Re: St. Lucie Unit 2  
Docket No. 50-389  
Order (EA-03-009) Interim RPVH Inspection Requirements  
Revised Relaxation Requests 1 and 2 - Supplement 4

**ST. LUCIE UNIT 2 RELAXATION REQUEST NO. 1 REVISION 2  
FROM US NRC ORDER EA-03-009**

**ST. LUCIE UNIT 2 RELAXATION REQUEST NO. 2 REVISION 1  
FROM US NRC ORDER EA-03-009**

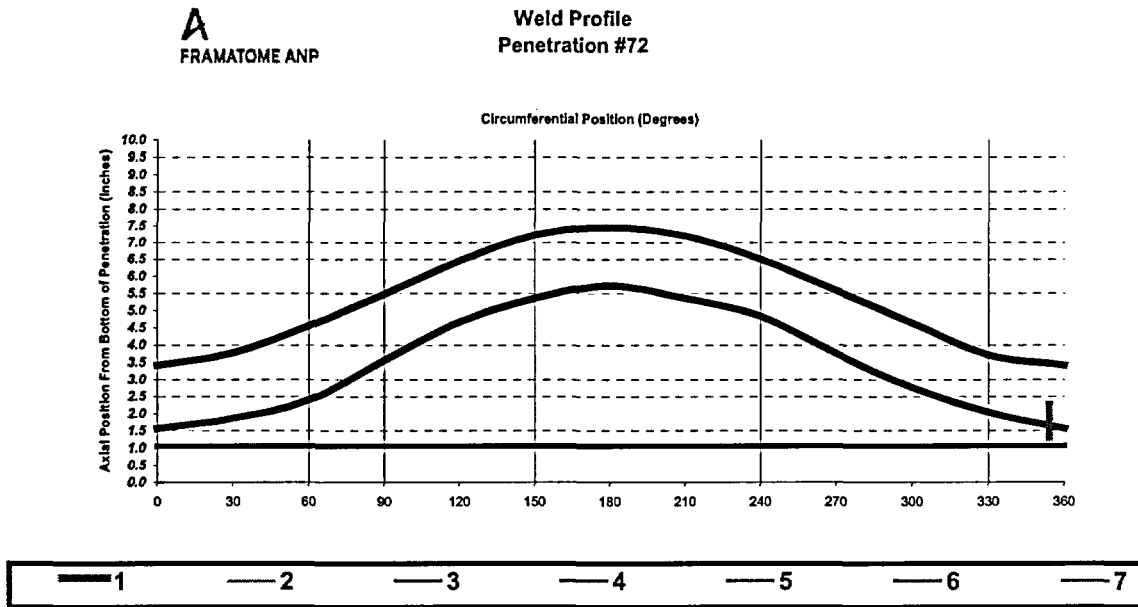
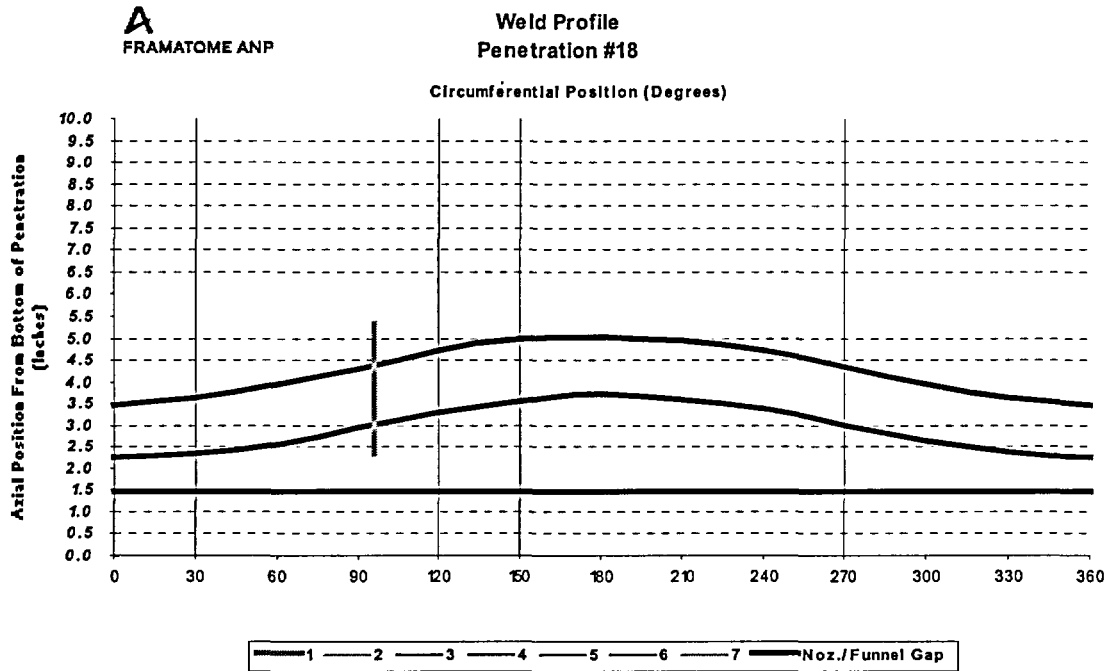
**NRC Question 3:** Provide the location of the flaw for Penetration Nos.18 and 72 relative to the weld and azimuthal angle around the nozzle.

**FPL Response to Question 3:** A single flaw was identified in Nozzle Nos. 18 and 72 at St. Lucie Unit 2. The details of each are provided in the table below. A graphical weld profile and flaw orientation is also provided. The 0° is identified as lowest downhill position of the weld.

Nozzle #	Flaw Location /Type	Azimuthal Location	Flaw Length	Flaw Depth	Distance Below Weld
18	OD Axial	96°	2.98"	0.26"	0.71"
72	OD Axial	354°	0.96"	0.28"	0.35"
